SUBJECT: W.P. 279-64-2, Site Plan 37-797,
Bridge No. 7,
The West Mall over Dundas Street,
District No. 6.

Bridge No. 7
The West Mall over Dundas St. & Ramps
W.P. 279-64-2, Site No. 37-797
Dundast St. & Hwy. 27 Interchange
District No. 6

Attached herewith are prints of the Preliminary Bridge Plan
Drawing D6202-P1 for the above-mentioned structure.

Mr. C. S. Grebski,
Bridge Design Engineer,
Bridge Division,
Admin. Bldg.

GENERAL ARRANGEMENT

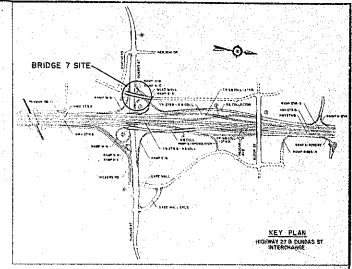
Bridge #7 (W.P. 279-64-2)

No comments.
